Change No. 17  
License No. DPR-16

By letter dated September 7, 1973, you submitted a request for a change to the Technical Specifications for Oyster Creek Nuclear Generating Station that would raise the limit for the average planar linear heat generation rate (APLHGR) for Type III E fuel from 10.3 kW/ft to 11.5 kW/ft. You submitted, as a basis for this increase, a report entitled "The Effect of Passive Central Rods on Heat Transfer During Spray Cooling of BWR Fuel Bundles".

Based on the above considerations, we conclude that Change No. 17 to the Technical Specifications that modifies the limits for APLHGR (Fig. 3.10.1) does not present a significant hazards consideration and that there is reasonable assurance that the health and safety of the public will not be endangered.

Figure 3.10.1 Maximum Allowable Average Planar Linear Heat Generation Rate

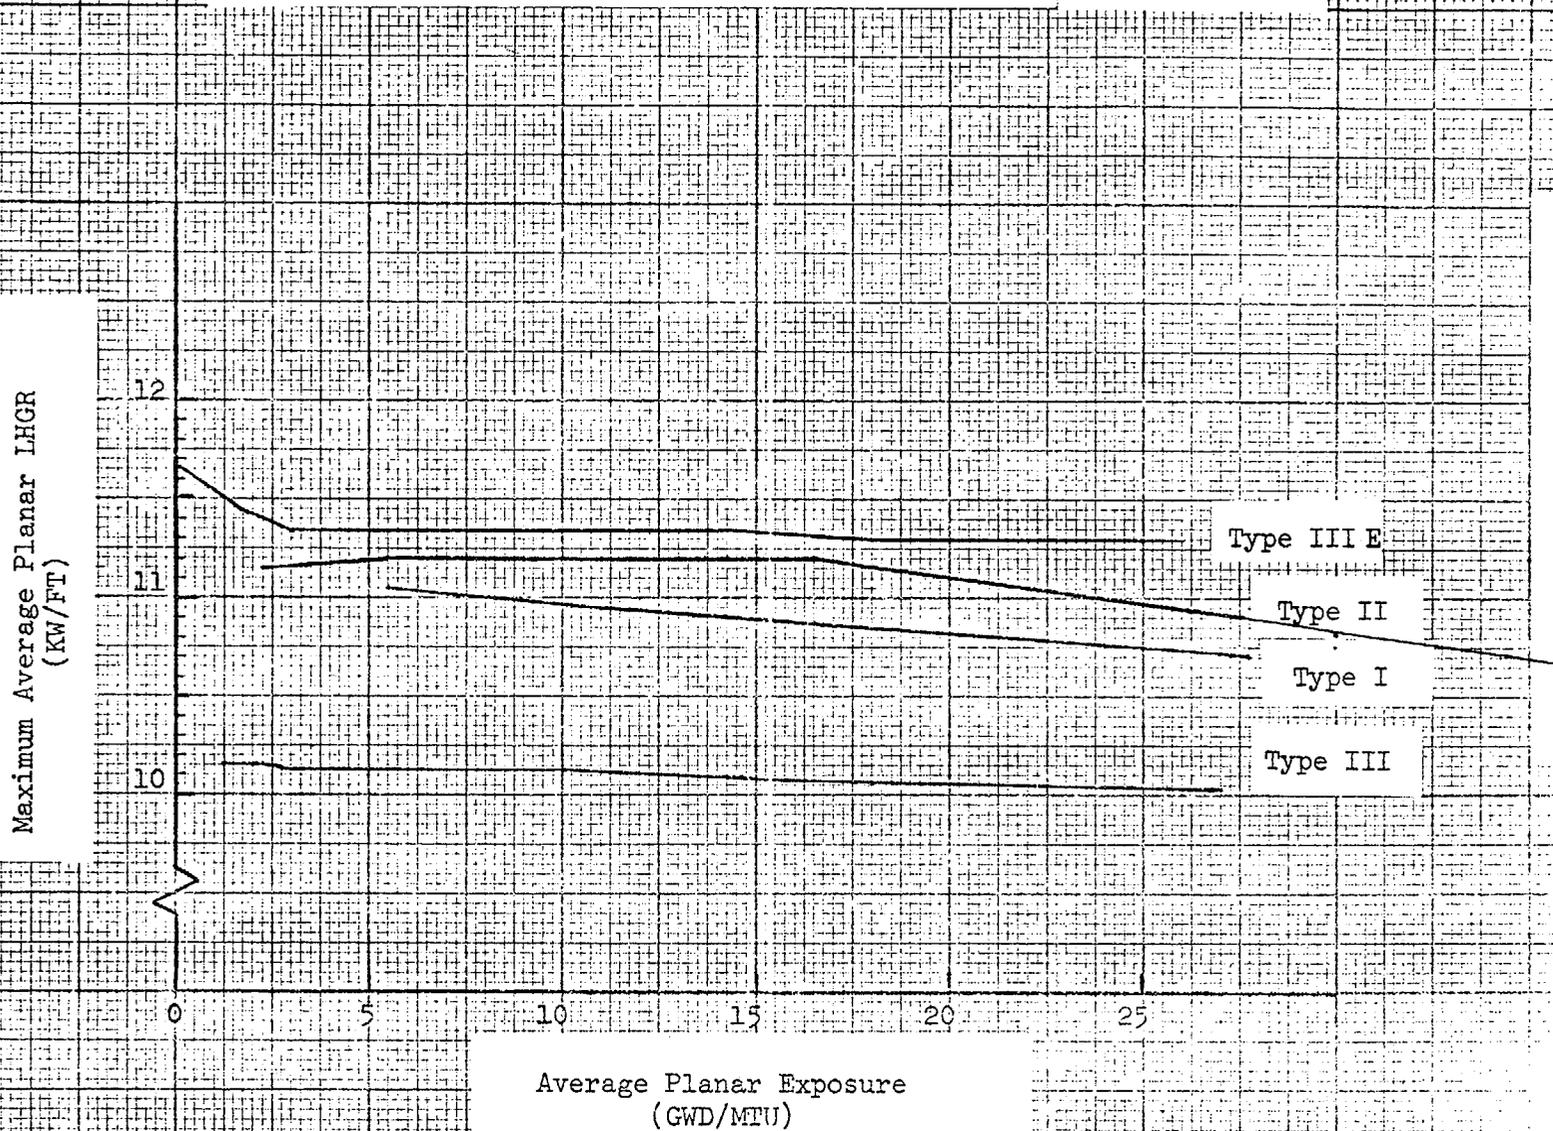
Accordingly, pursuant to 10 CFR Part 50, Section 50.59, the Technical Specifications of Provisional Operating License No. DPR-16 are hereby changed by replacing the existing page 3.10-2 and Figure 3.10.1 with the enclosed revised page and figure.

The maximum average planar LHGR shown in Figure 3.10.1 for Type III and III E fuel are the result of the calculations presented in Supplement No. 3 to Facility Change Request No. 4 dated April 17, 1973, as amended by Attachment 1 to Jersey Central Power & Light Company letters dated August 15, 1973, and November 5, 1973. These calculations were made to determine the effect of densification on peak clad temperature following a postulated LOCA and include the results of detailed heatup calculations to maximum planar exposure of 26,000 MWD/MT.
